October 07, 2019

## WABASH VALLEY HEATH CENTER 1436 LOCUST STREET TERRE HAUTE, INDIANA 47807 BUILDING ADDITIONS & RENOVATION

### ADDENDUM #1

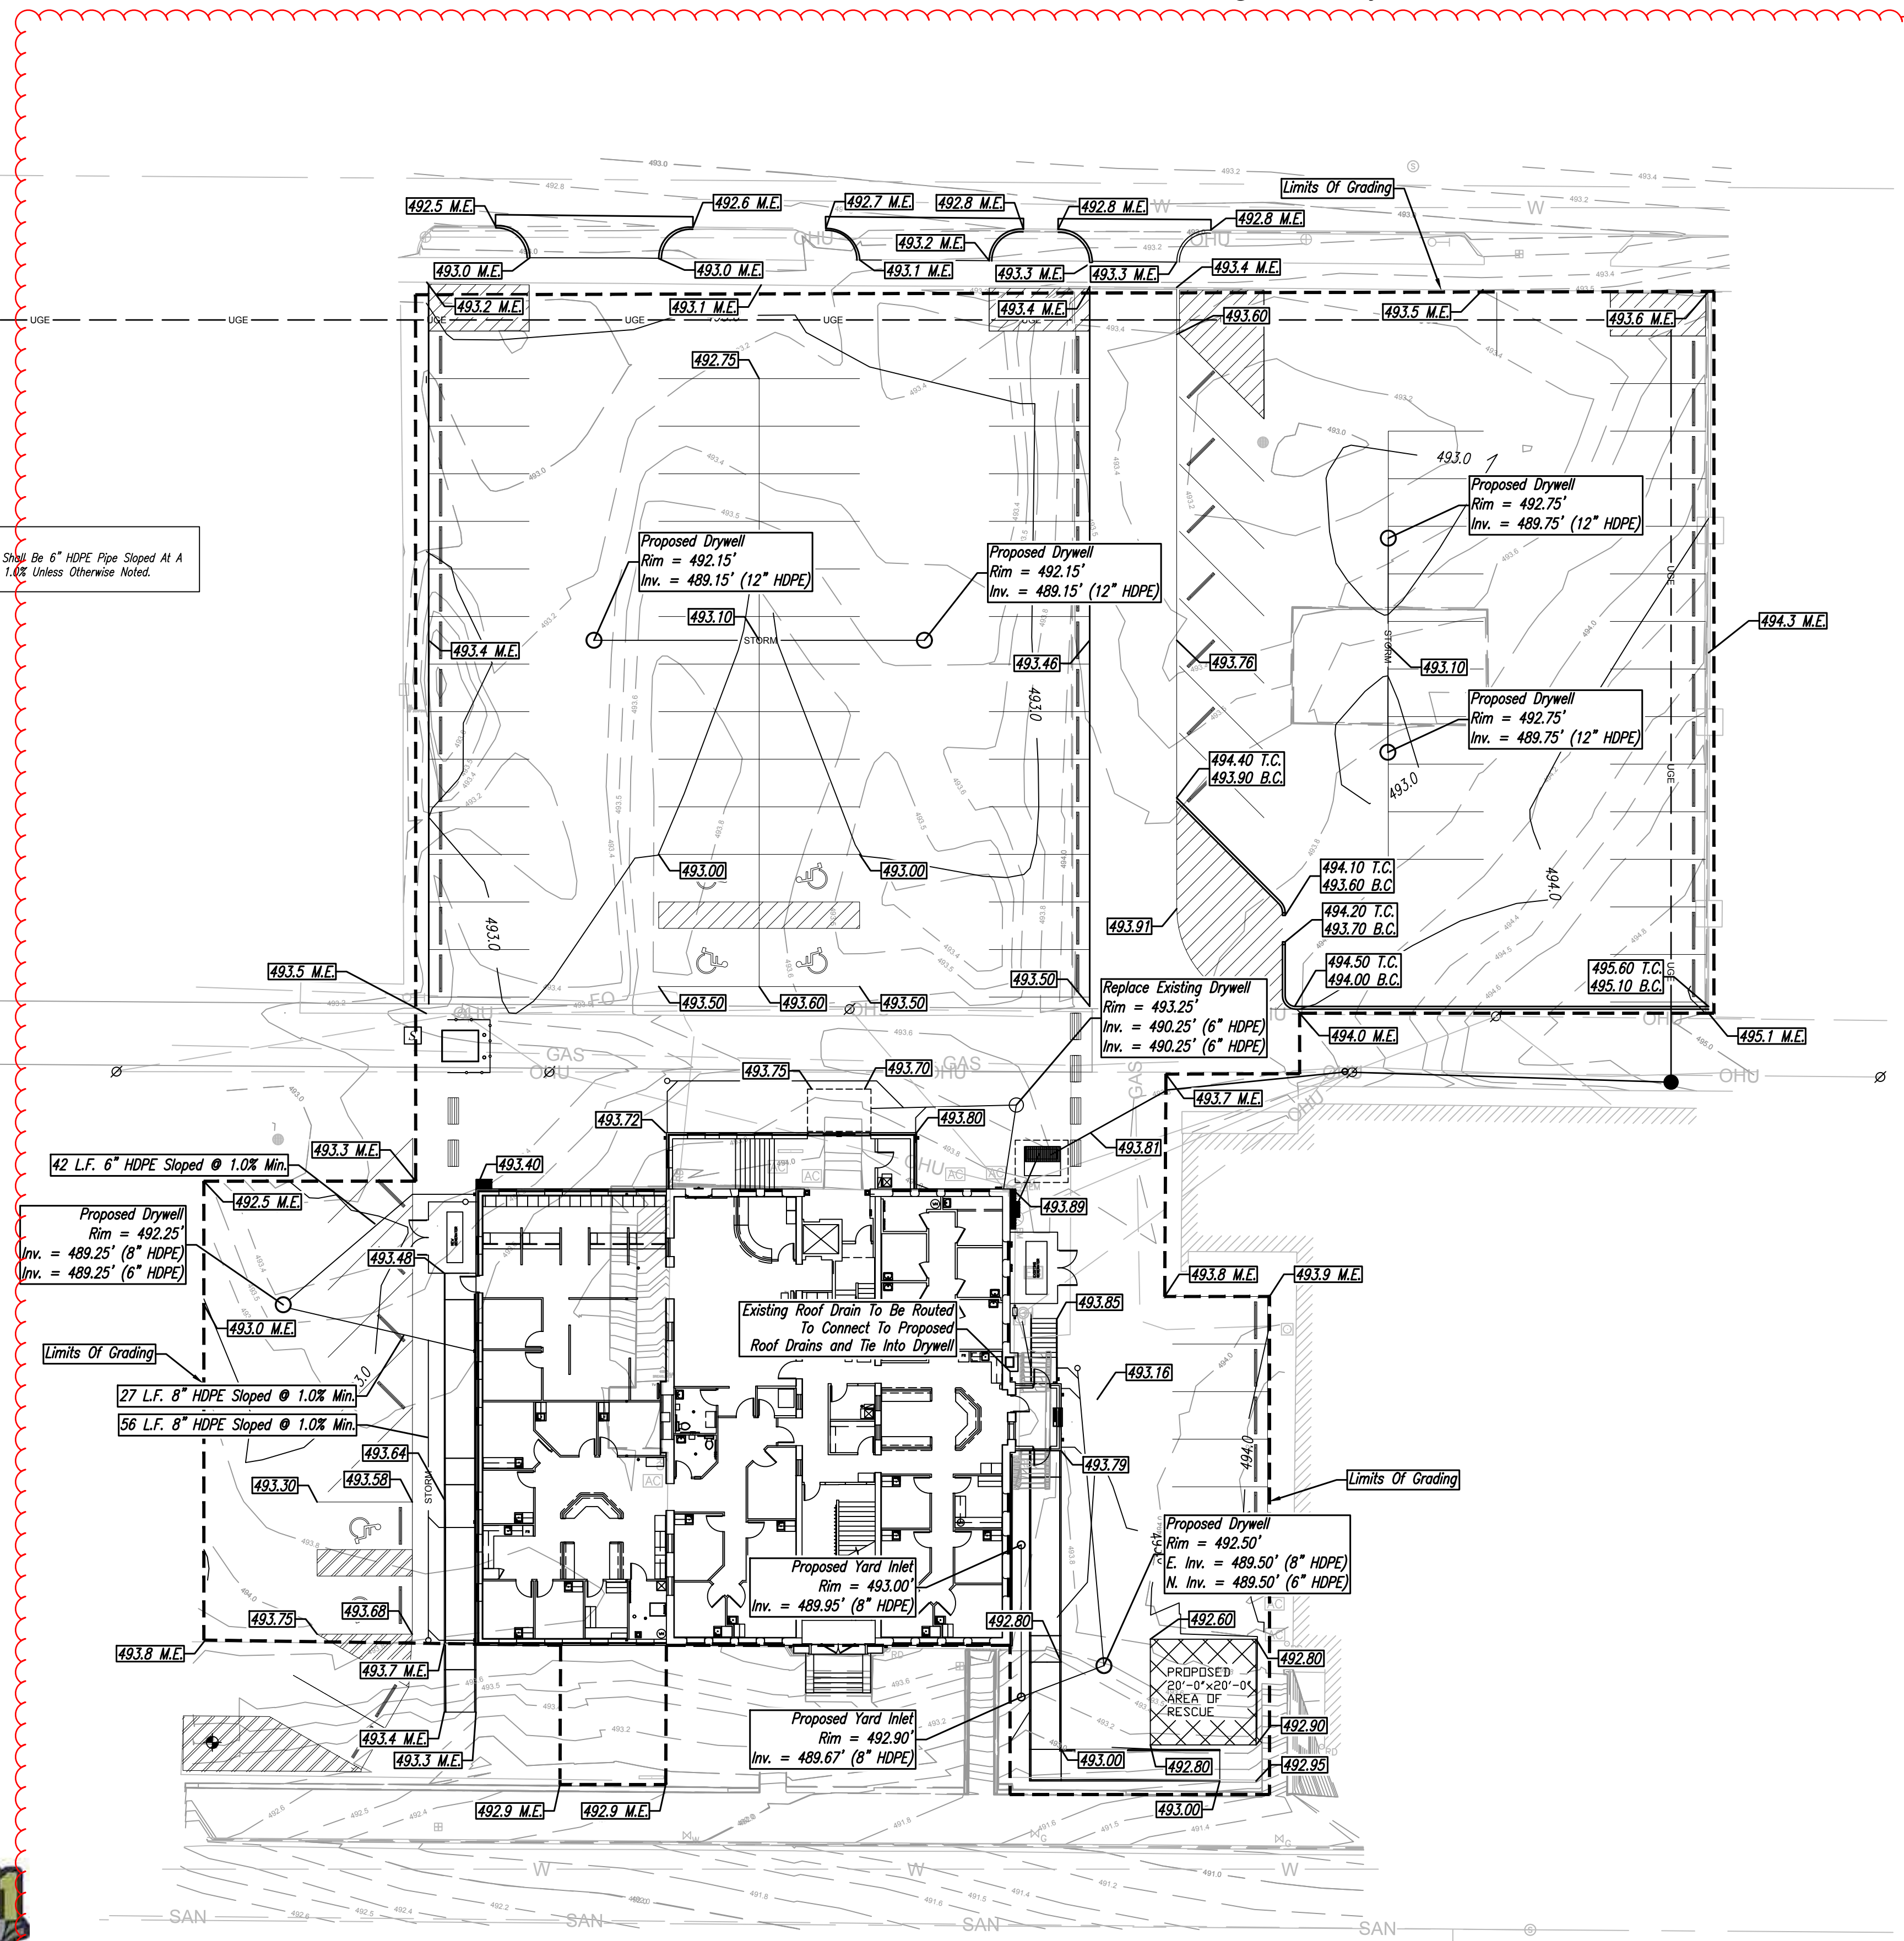
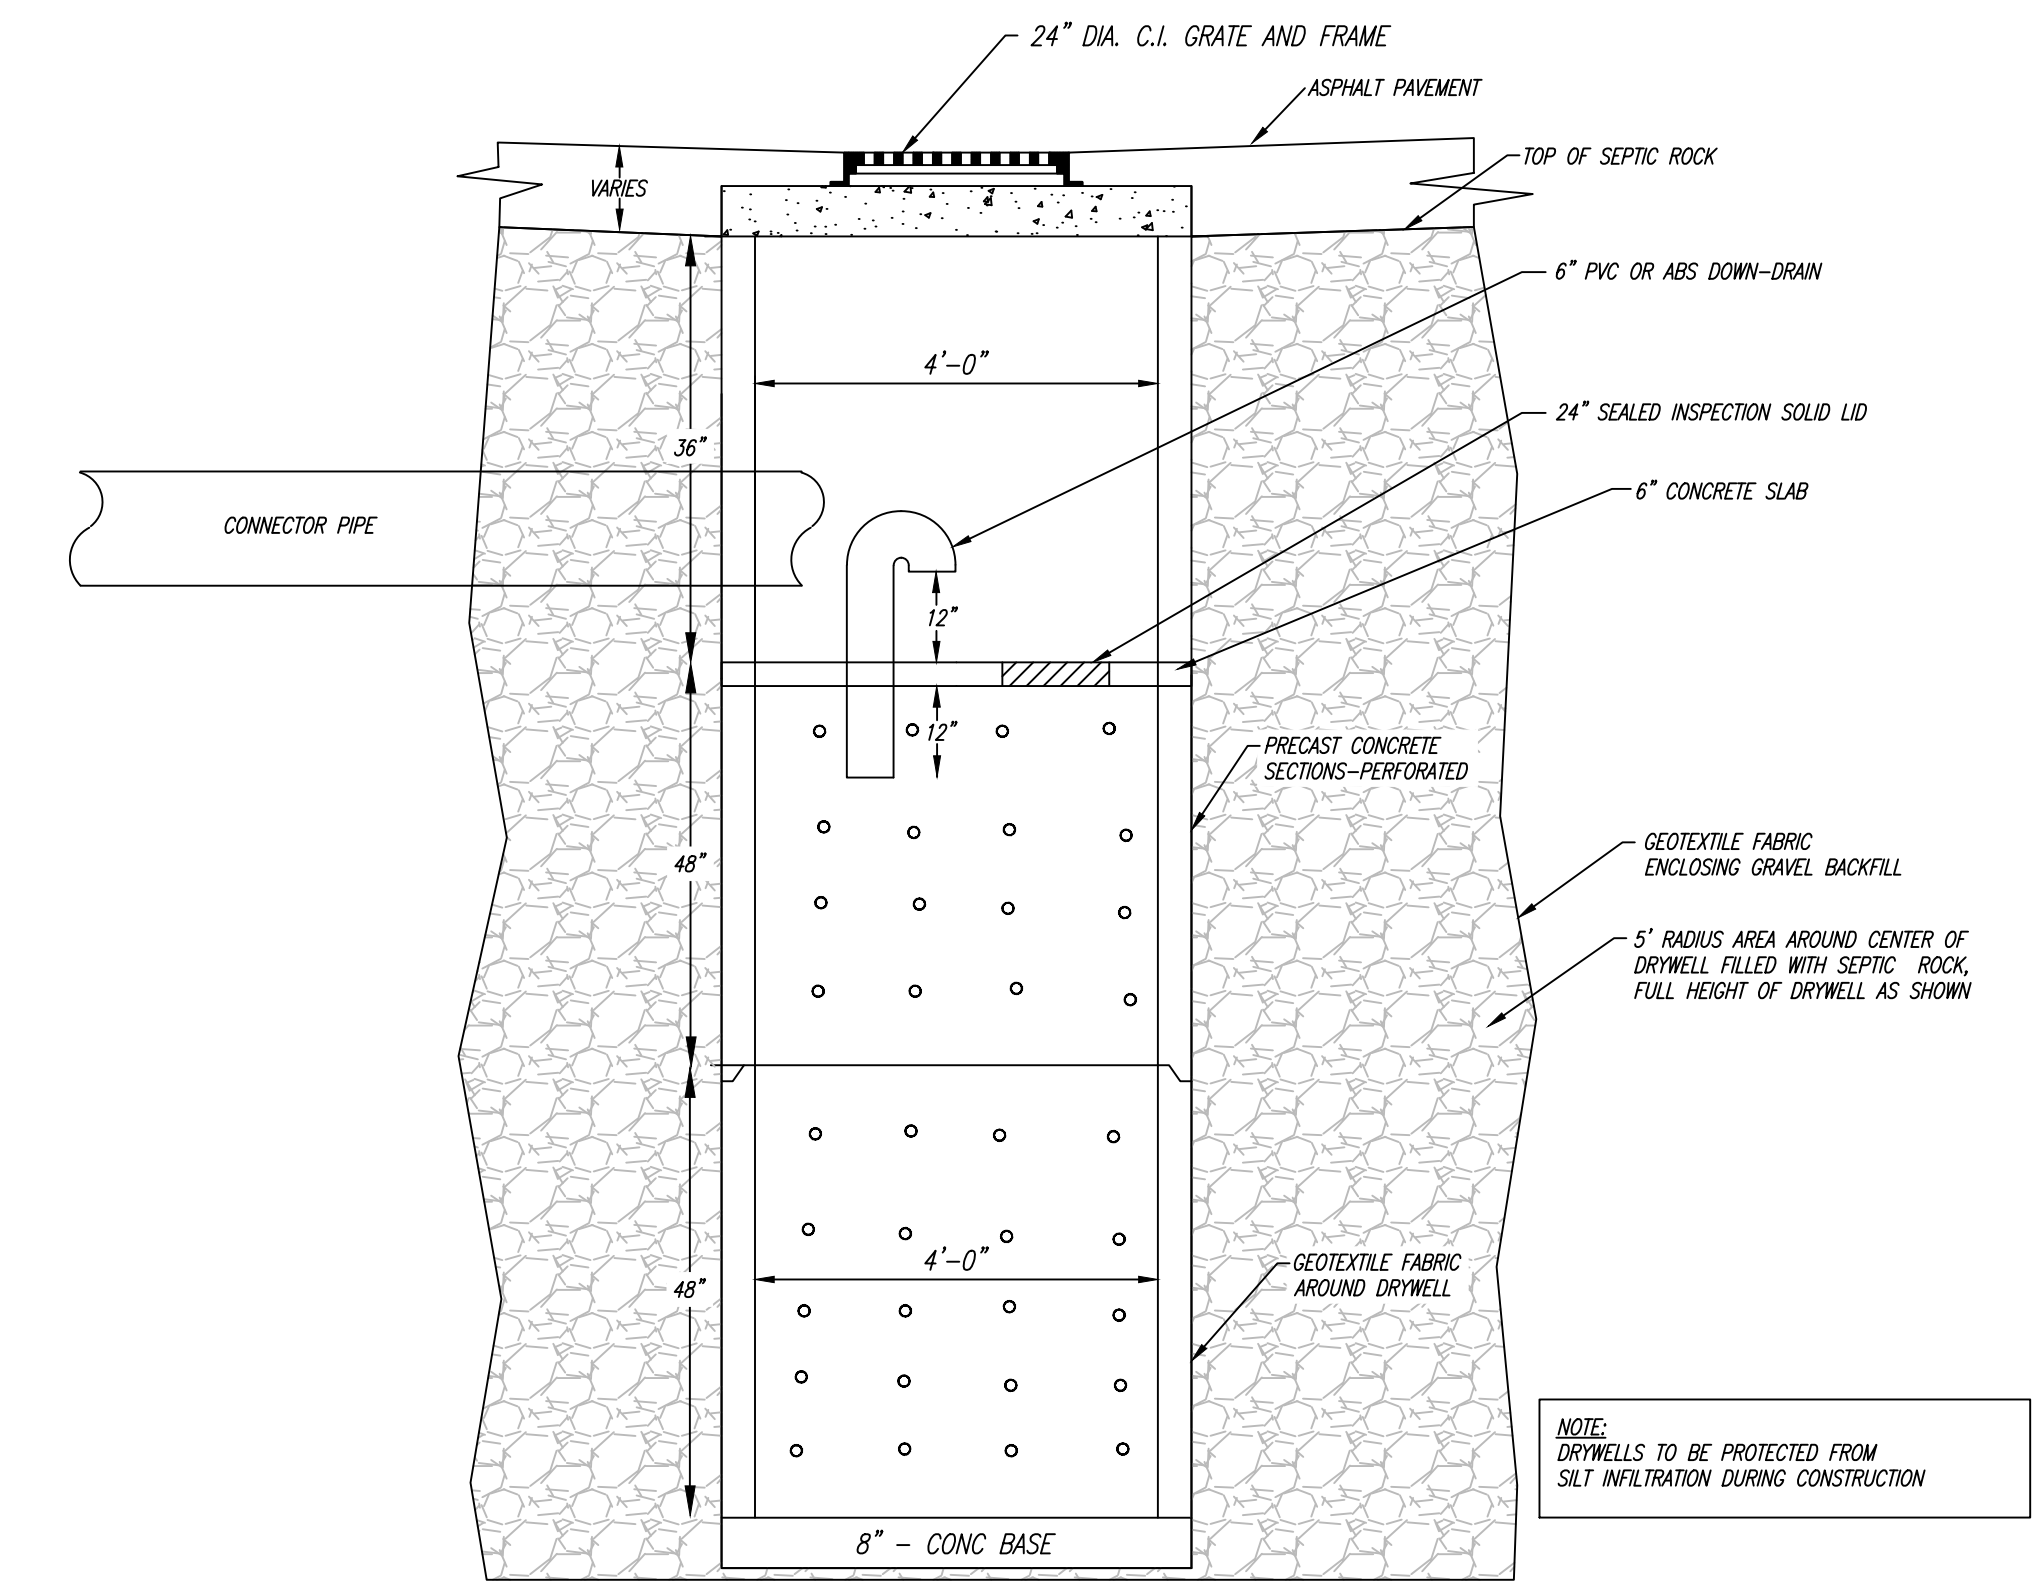
Attached to this Addendum #2 is a revised Drawing #C1.0 Drainage Plan by Myers Engineering, Inc.

This drawing provides additional existing grade elevations to be used for site work bidding.
